October 21, 1986

The Commission has issued the enclosed Amendment No. 10 to Facility Operating License No. DPR-80 and Amendment No. 8 to Facility Operating License No. DPR-82 for the Diablo Canyon Nuclear Power Plant, Unit Nos. 1 and 2, respectively. The amendments consist of changes to the Technical Specifications in response to your application transmitted by letter dated June 10, 1986, as supplemented August 19, 1986.

PACIFIC GAS AND ELECTRIC COMPANY
DIABLO CANYON NUCLEAR POWER PLANT, UNIT 1
DOCKET NO. 50-275
AMENDMENT TO FACILITY OPERATING LICENSE

ATTACHMENT TO LICENSE AMENDMENT NOS. 10 AND 8
FACILITY OPERATING LICENSE NOS. DPR-80 AND DPR-82
DOCKET NOS. 50-275 AND 50-323

FIGURE 2.1-1a
 REACTOR CORE SAFETY LIMIT (UNIT 1)

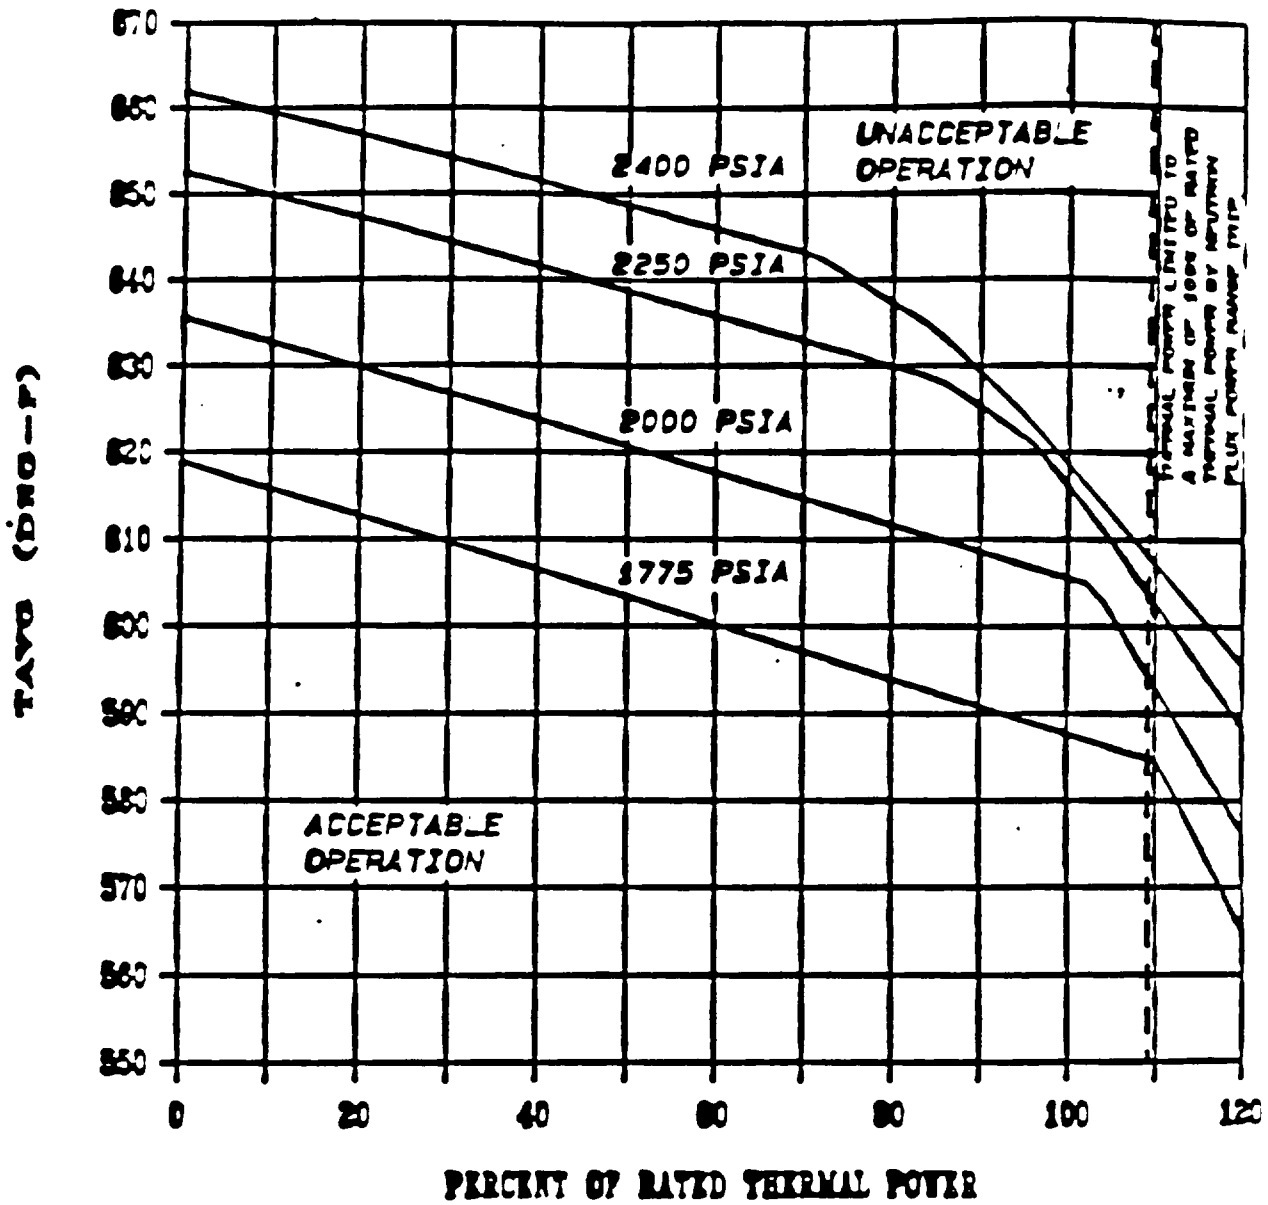
The licensee proposes to change the F^N-delta-H partial power multiplier from 0.2 to 0.3 at low power. The change involves Technical Specification Section 3/4.2.3, Figure 3.2-3a, Bases 2.1.1, and Figure 2.1-1. The proposed revision would allow optimization of core loading patterns by minimizing the restriction on F^N-delta-H at lower power levels. The increase in the partial power multiplier from 0.2 to 0.3 has a direct impact on DNBR calculations. We have previously approved a 0.3 partial power multiplier for a number of operating plants including Turkey Point, Ginna, Trojan, Cook Unit 1, Zion, Indian Point Unit 3, Point Beach, and Surry.

The licensee assessed the impact of larger F^N-delta-H on thermal-hydraulic design, nuclear design, and accident conditions. The results showed that (1) the DNBR safety limit is not violated, (2) there is no impact on other nuclear design bases, and (3) overtemperature and overpower setpoints are not impacted by the proposed F^N-delta-H change for non-LOCA accidents and the F^N-delta-H increase has no effect on the LOCA analyses. We thus consider that the Technical Specification changes involving Section 3/4.2.3, Figure 3.2-3a, Bases 2.1.1, and Figure 2.1-1 of F^N-delta-H are acceptable.

The curves are based on an enthalpy hot channel factor, $F_{\Delta H}^N$ of 1.55 and a reference cosine with a peak of 1.55 for axial power shape. An allowance is included for an increase in $F_{\Delta H}^N$ at reduced power based on the expression:

$$F_{\Delta H}^N = 1.55 [1 + 0.3 (1-P)] \text{ (Unit 1)}$$
